# LAZY Y AND ROCKING J SUBDIVISION

LOCATED IN THE SOUTH HALF OF SECTION 7,  
TOWNSHIP 12 SOUTH, RANGE 63 WEST OF THE 6TH P.M.  
COUNTY OF EL PASO, STATE OF COLORADO

JANUARY 30, 2026  
SHEET 2 OF 2

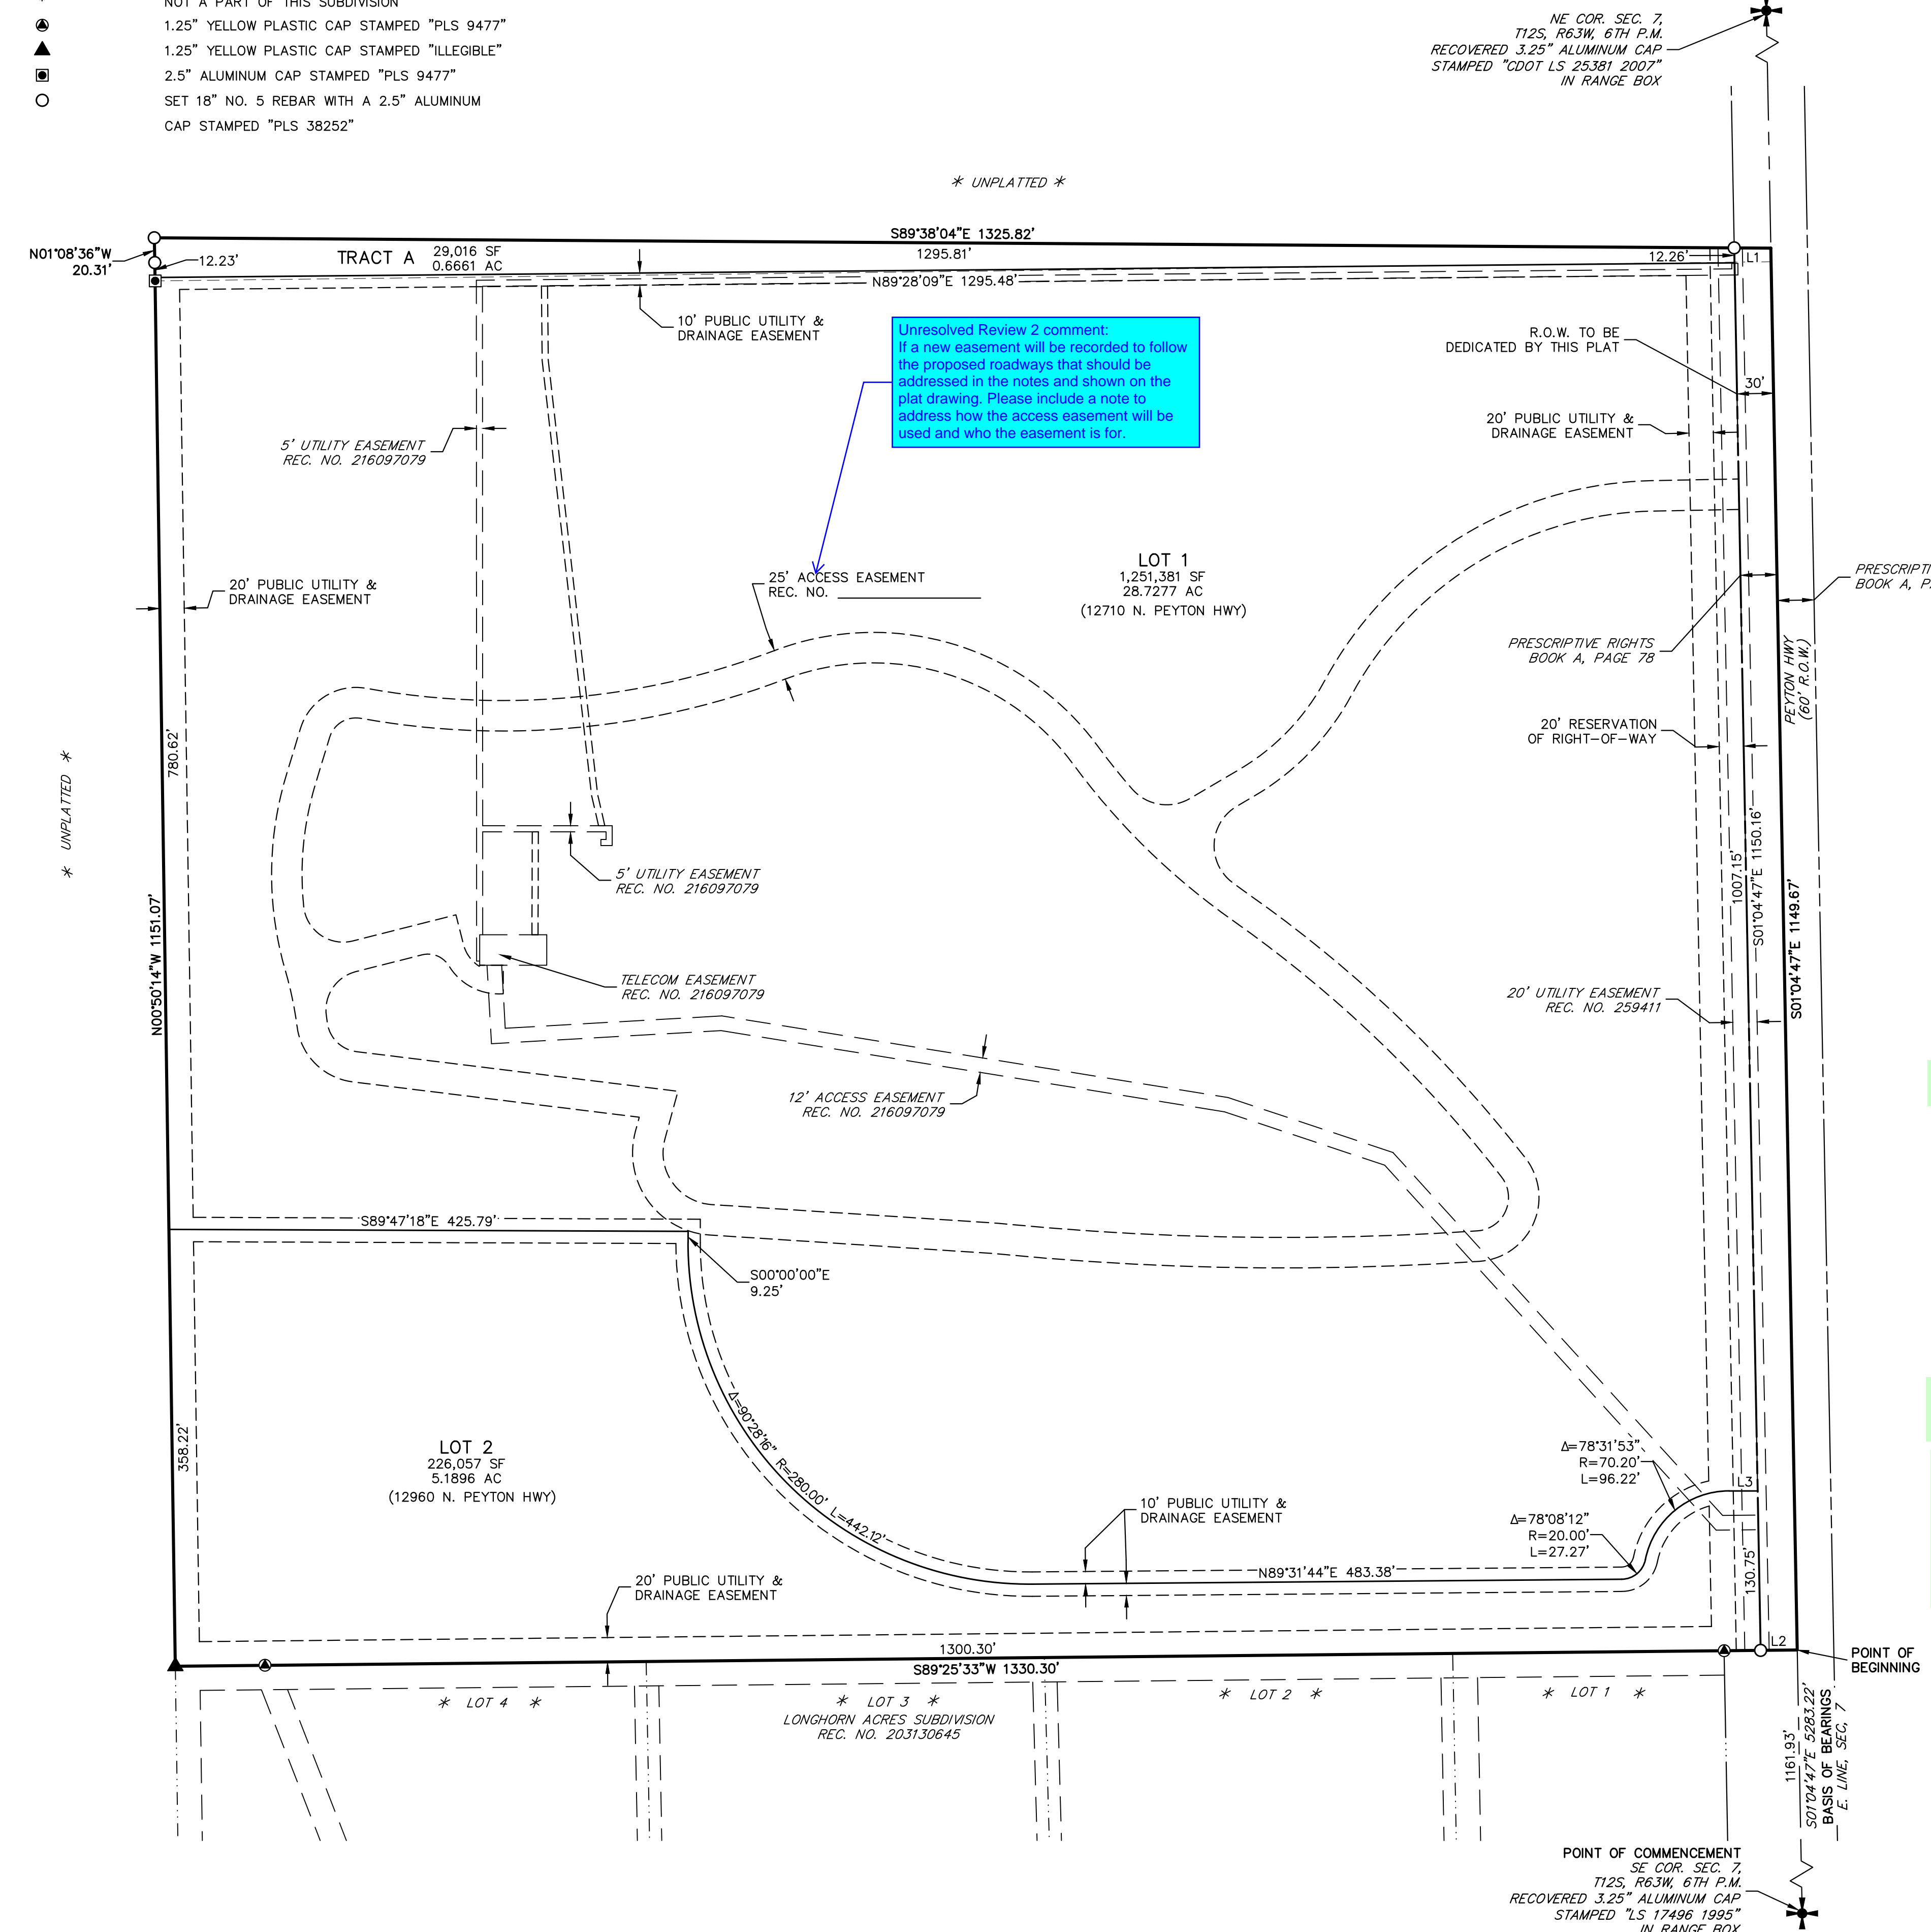
Unresolved Review 2 comment: If a new easement will be recorded to follow the proposed roadways that should be addressed in the notes and shown on the plat drawing. Please include a note to address how the access easement will be used and who the easement is for.
